Alteration and Additions - 45 Napier Street, Cottesloe

In reply to your email dated and received last 27 July 2012. Please note; we have made some considerable changes to the original proposed design in order to satisfy all the comments outlined in the email. We hope the revised design is in keeping with the standards of the Town Planning Scheme and RDC – and therefore meets with the council's recommendation for approval.

Regarding Development Application - #2466, 45 Napier St. Cottesloe:

DO HO! COVER DIVINITION							
POOL	HOUSE	- ELEV	& SECT				
SCALE	1:100	DATE	JAN '12				
JOB No.	120101	DRAWING No.	A09 (C)

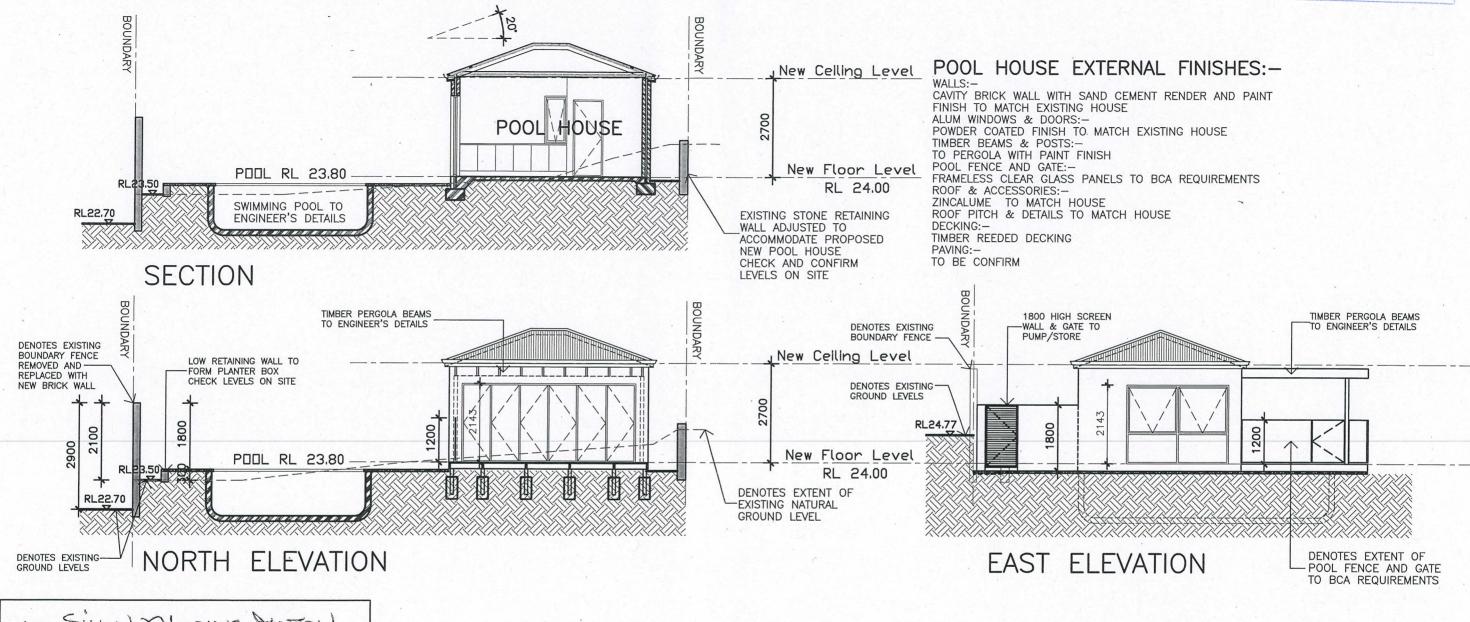
The proposed pool pump is fully enclosed which will reduce the noise. Although the enclosure is 1230mm from the boundary – the actual pump will be positioned hard up against the pool house wall which is 2870mm from the boundary.

\odot DRAWING A01 SCALE 1:200 JOB No. 120101

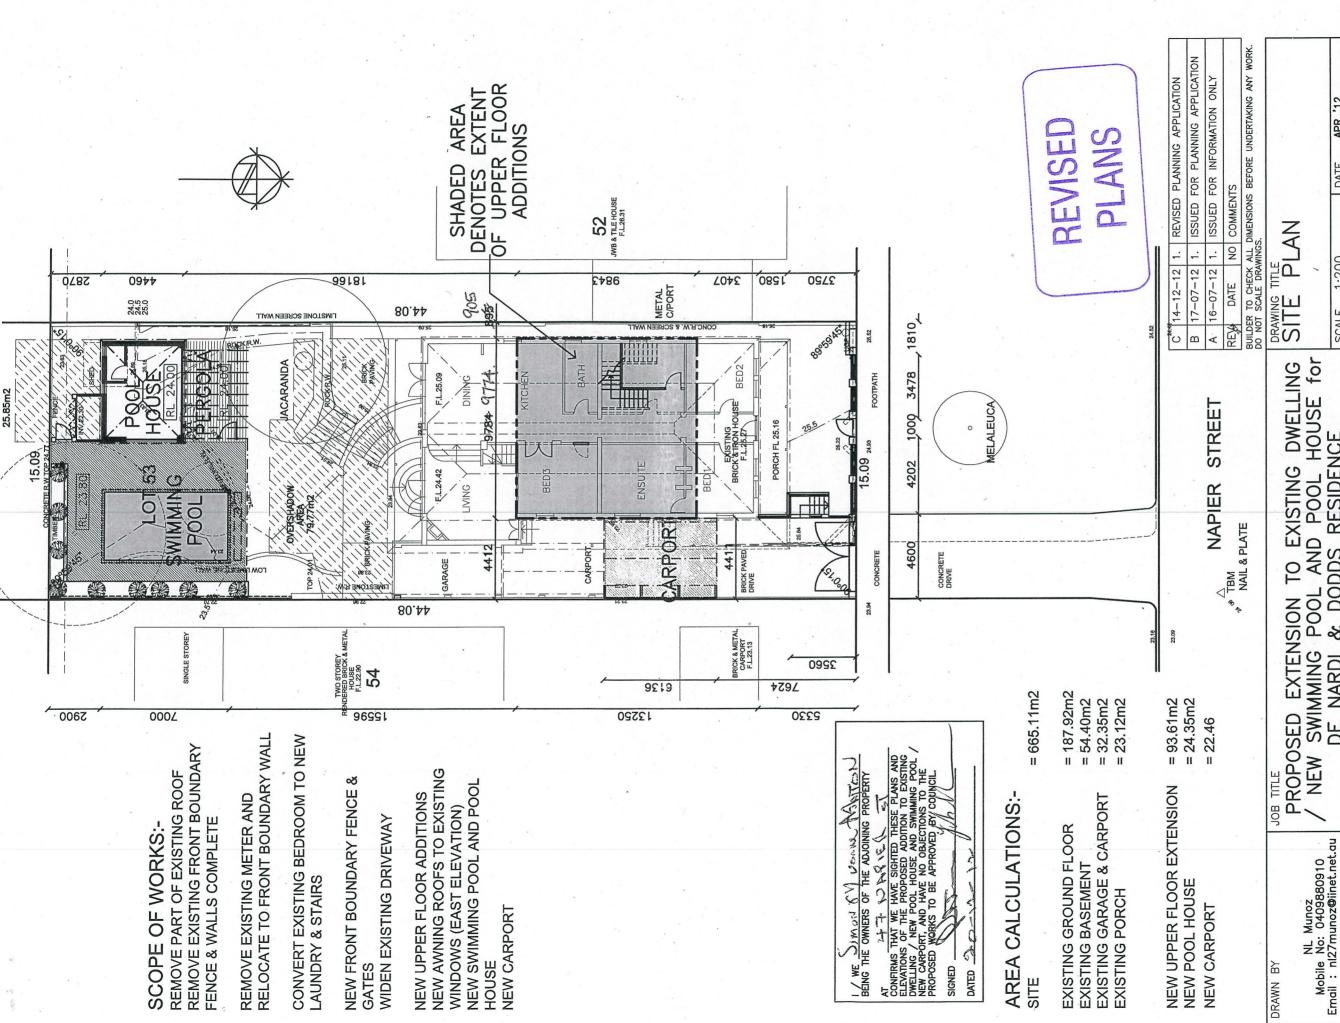
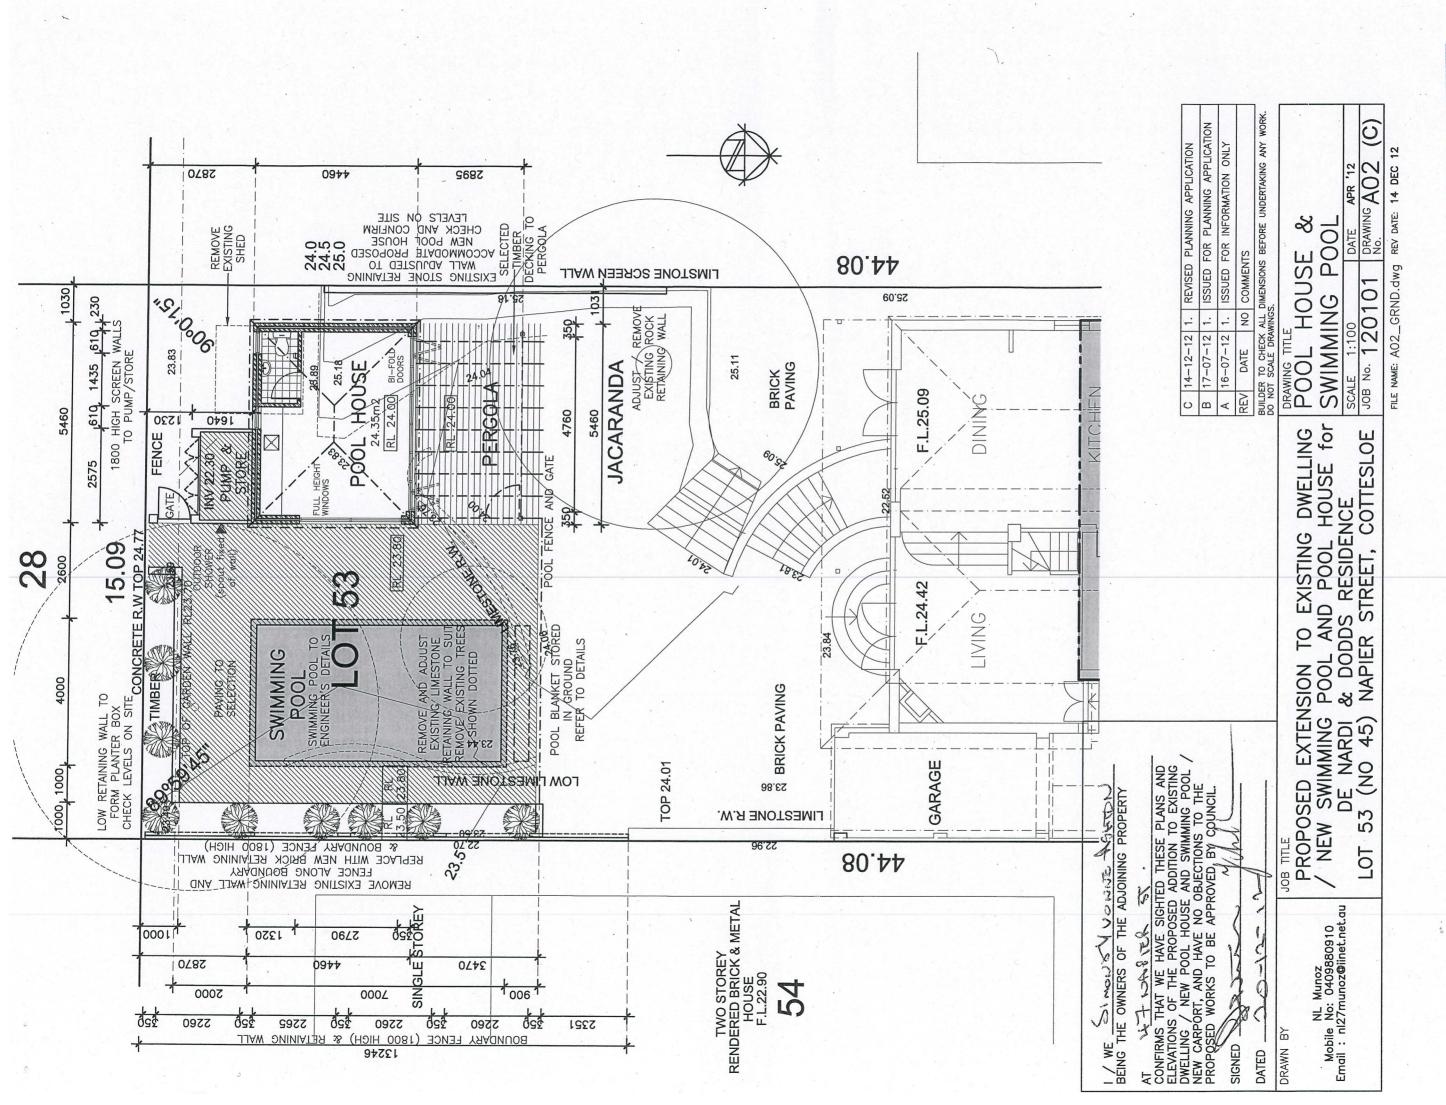
I object on the strongest possible terms to any concession regarding extension of the west façade 1st floor addition.
 The west façade must be set back no less than 1.5m FROM THE BOUNDARY LINE.

3. I object to the south facing upper bedroom window #3 (S.W) overlooking our backyard. It should be 1.6m above floor level, obscured glass or screened.

Note, as discussed with Mr. Ed Drewett, I am extremely concerned regarding the 0.905 dimension bdy/west façade, shown on the plan. I have very good reasons to believe it should be more like 0.800, or possibly less.
